**CARLETON PLACE ARENA
ADDITION AND RENOVATIONS
75 Neelin Street Carleton Place, Ontario**

CIR # 17

SITE INSTRUCTION NO. ME-05
MECHANICAL AND ELECTRICAL

Drawing:
WATER HEATER
RELOCATION

1 MECHANICAL ROOM (EXISTING)
MSK1 SCALE: 1/4" = 1'-0"

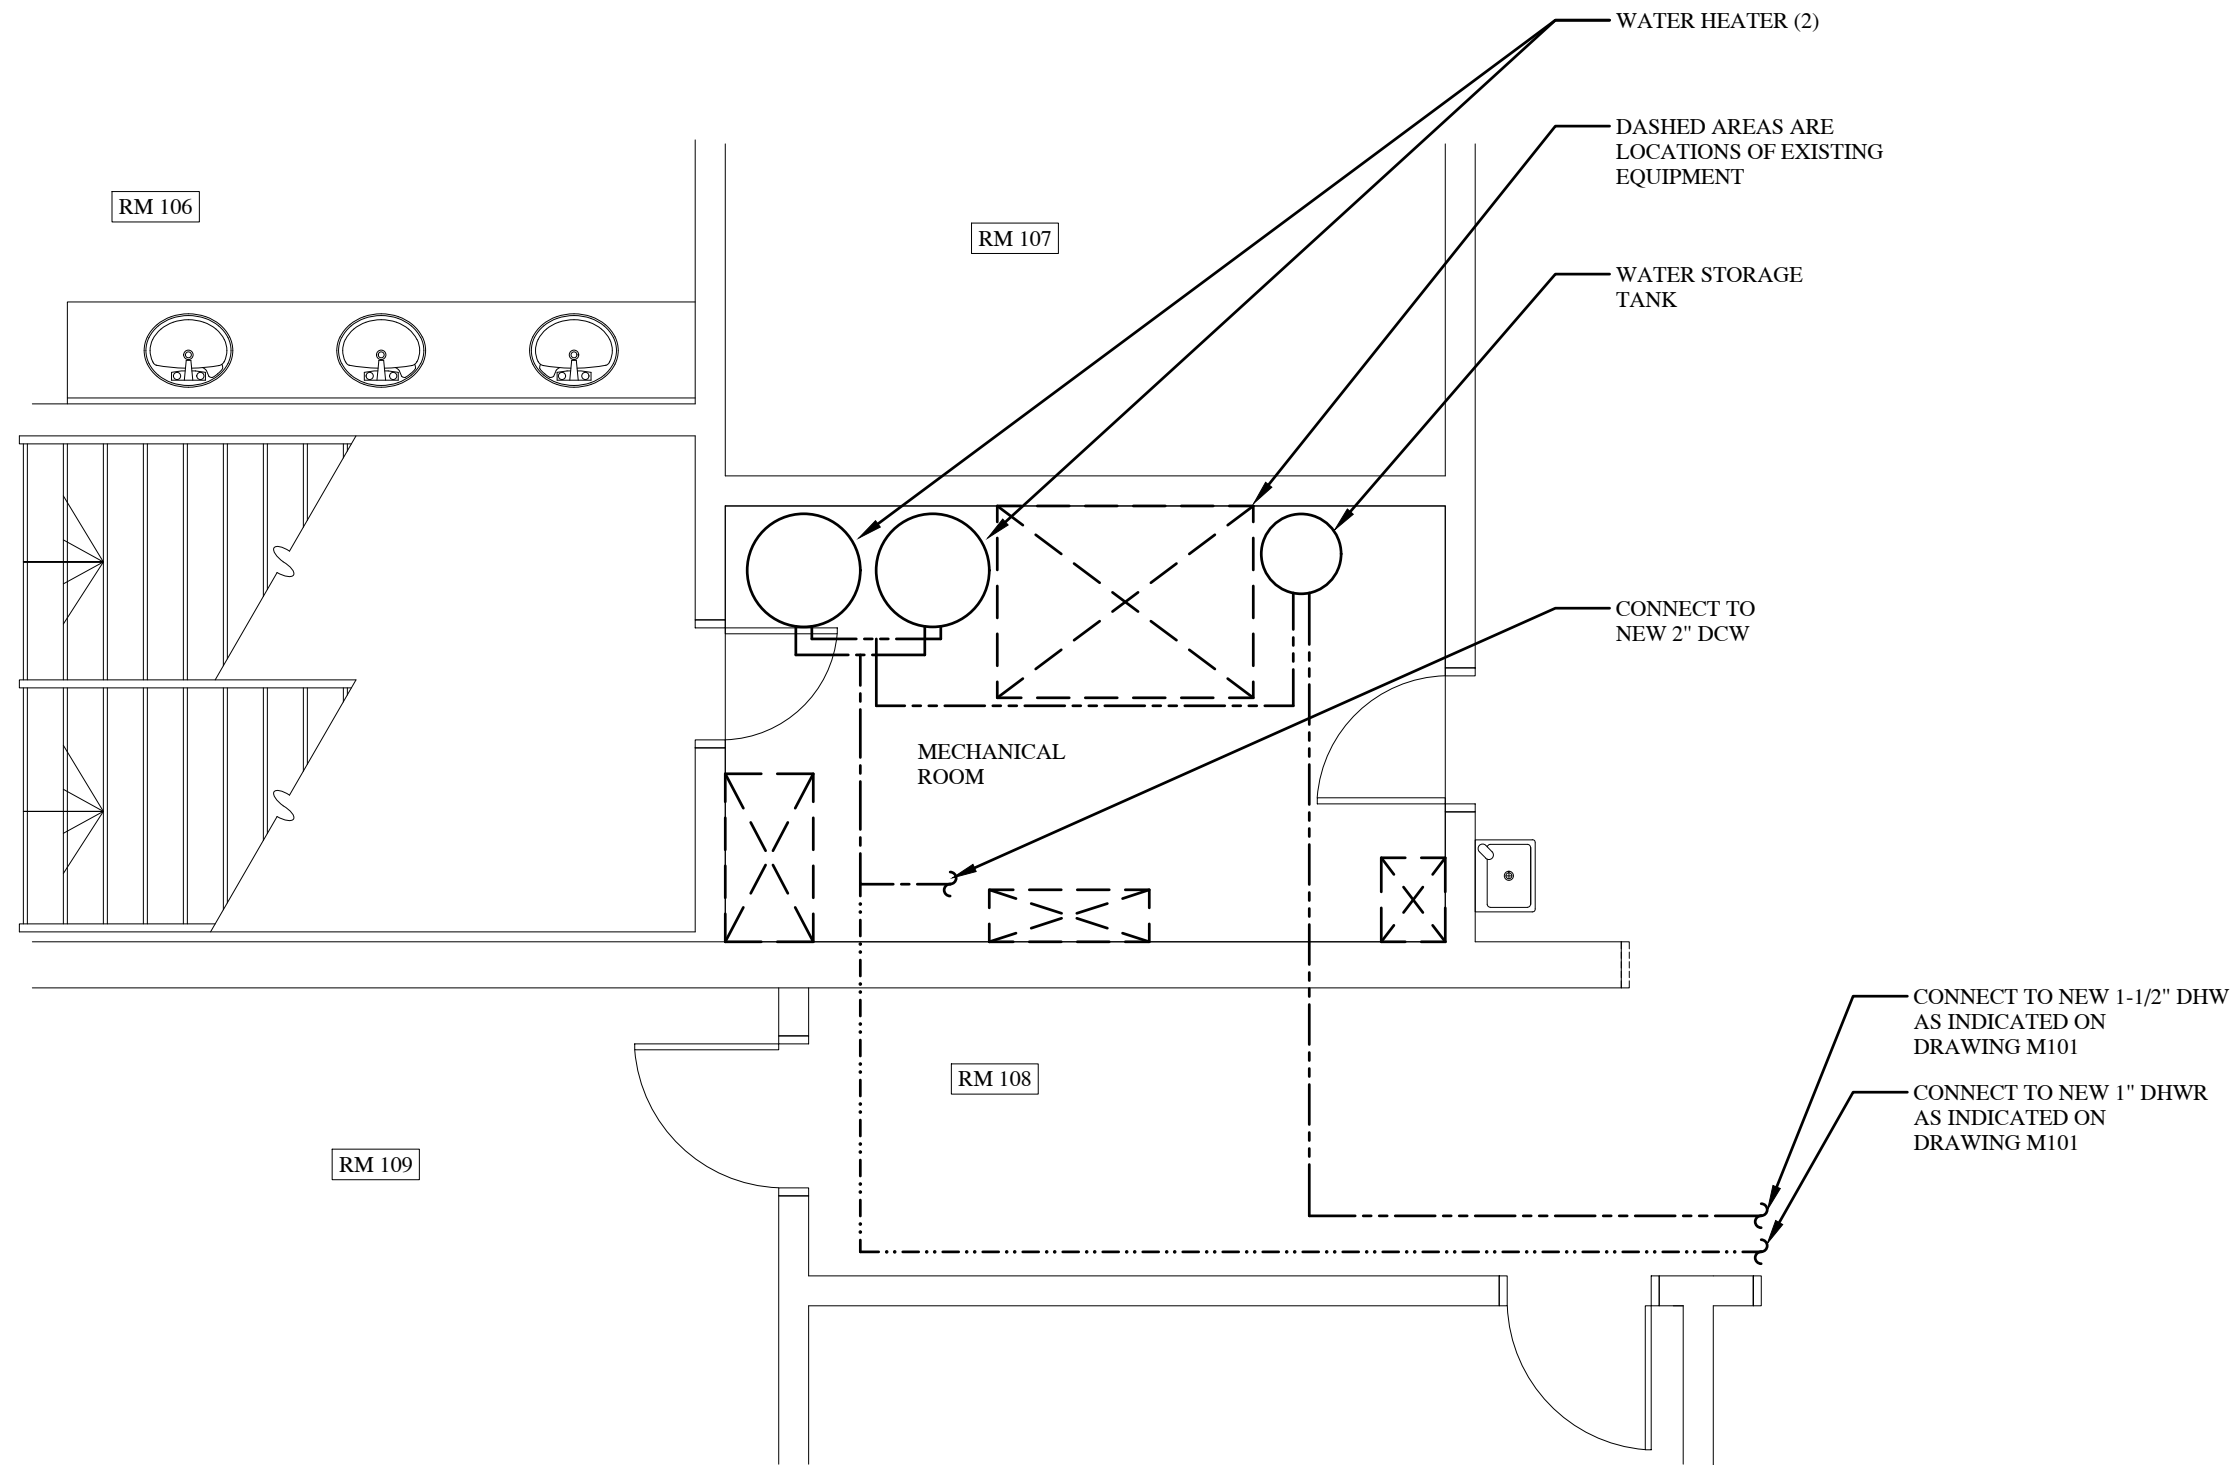
- M5.1 Relocate Water Heaters and Water Storage Tank to existing Mechanical Room, as follows:
- Refer to Attached Sketch MSK1, which indicates relocated equipment (all fittings, valves, pumps, etc., that are indicated on drawing M101 shall be provided).
 - All DCW, DHW & DHWR piping shall be insulated.
